**SECTION 00 90 04
BIDDING AND CONTRACT REQUIREMENTS
ADDENDUM NUMBER 4**

Issued: October 12, 2023

Re: ADDENDUM NUMBER (4) TO THE BIDDING DOCUMENTS FOR

**McHenry County College
University Center at MCC**
Architect's Project Number: 22-050

KEY PLAN:

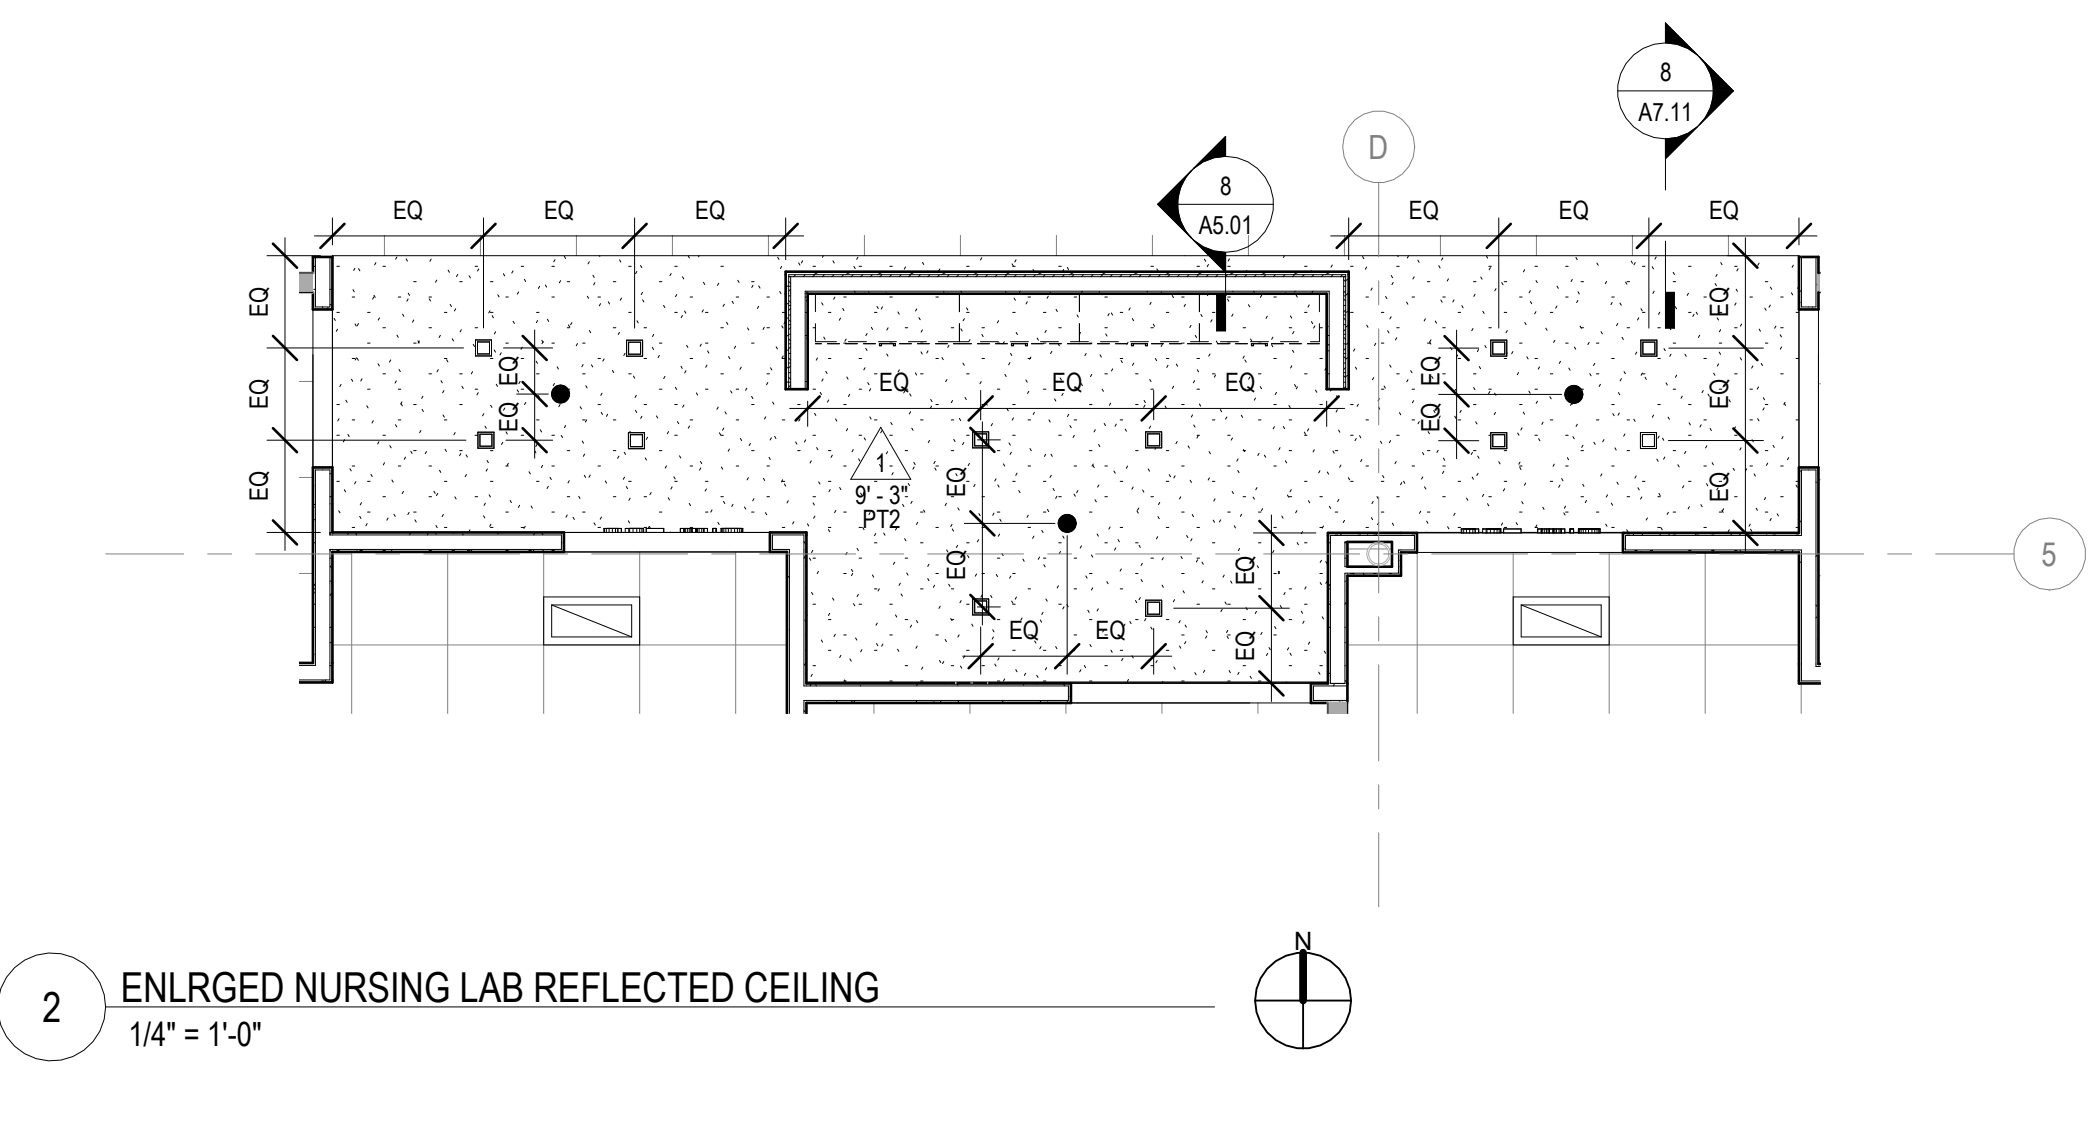
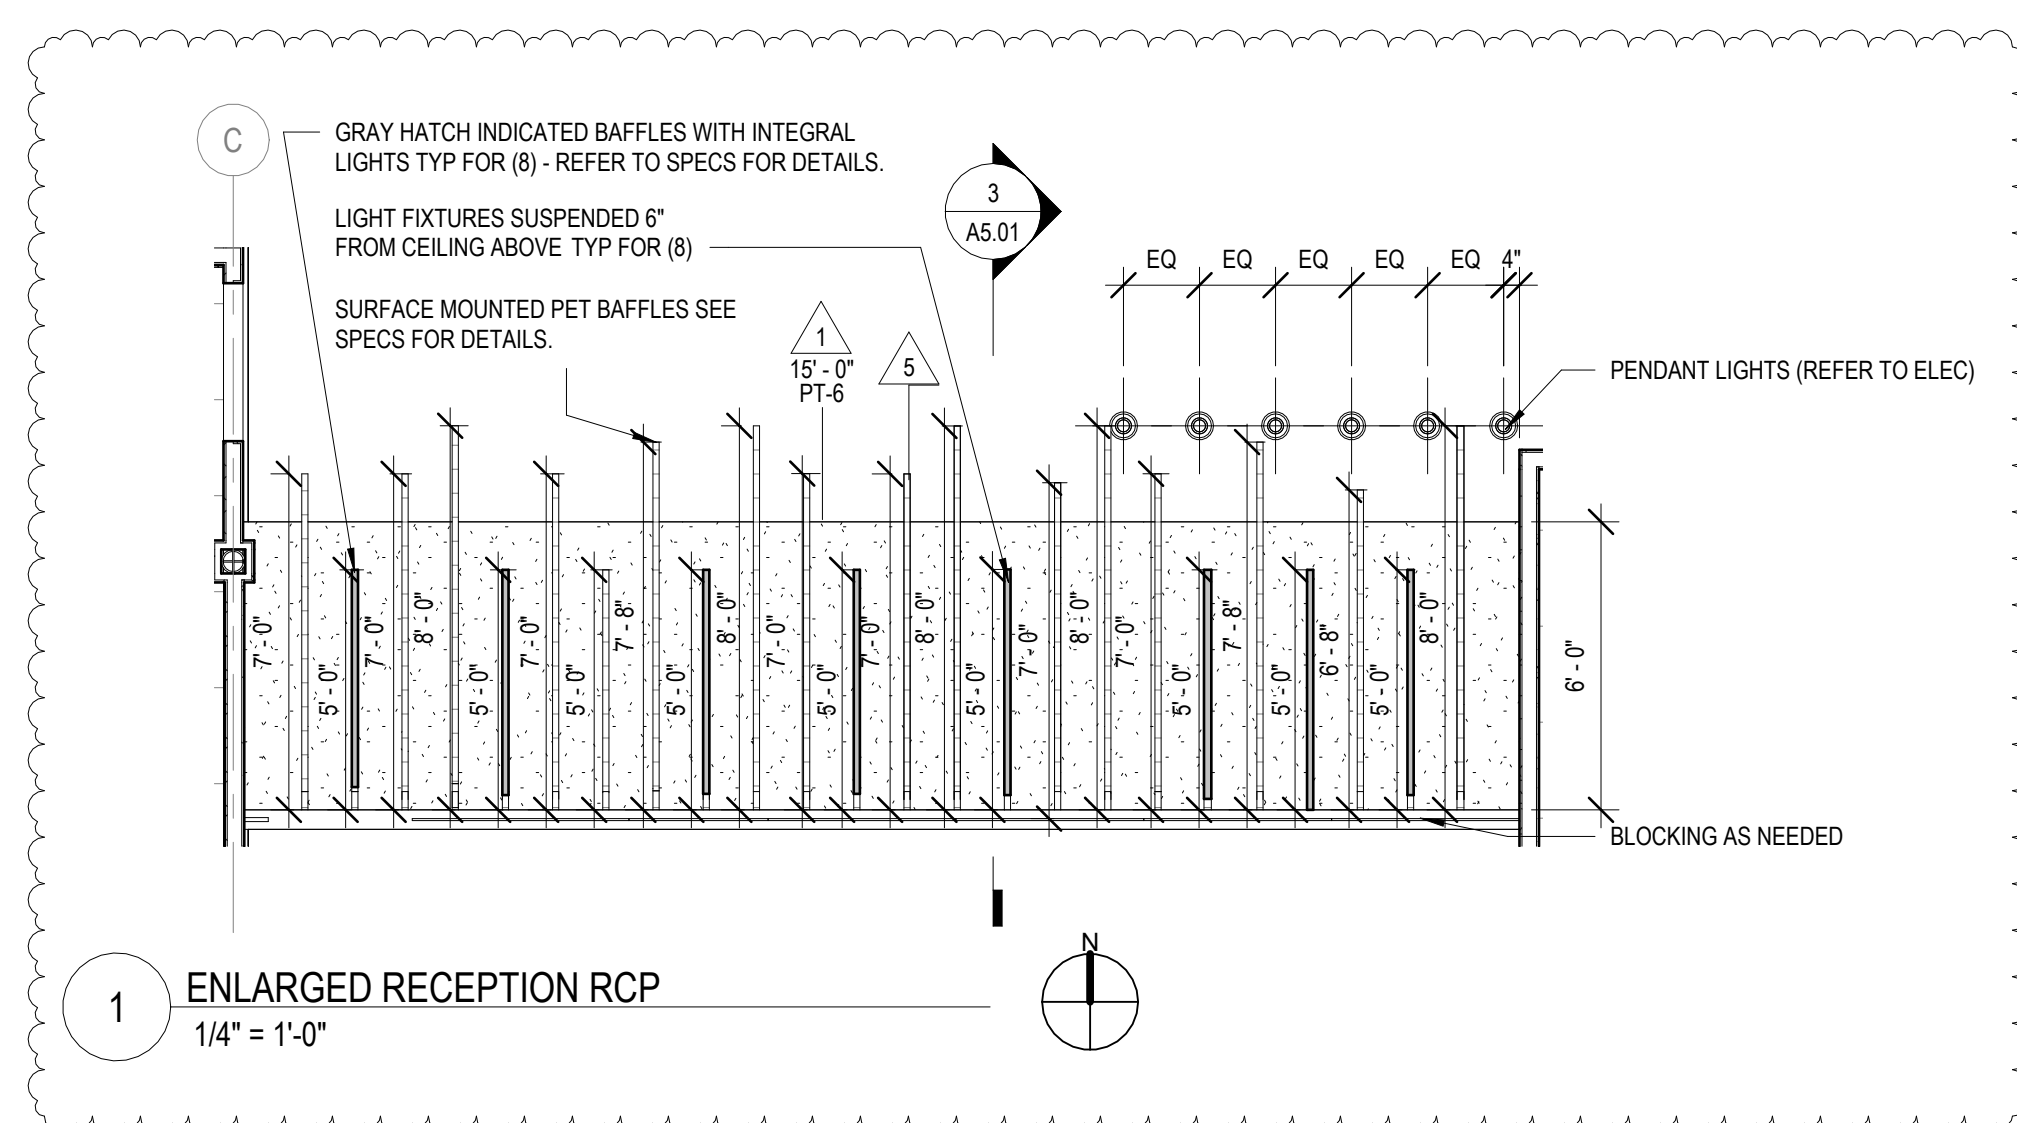
4. A2.51
 - A. **REVISE** enlarged RCP #1 as indicated.
5. A5.01
 - A. **REVISE** section 3 and 4 as indicated.
6. A7.10
 - A. **REVISE** details 7, 11, 12, 14, and 16 as indicated.
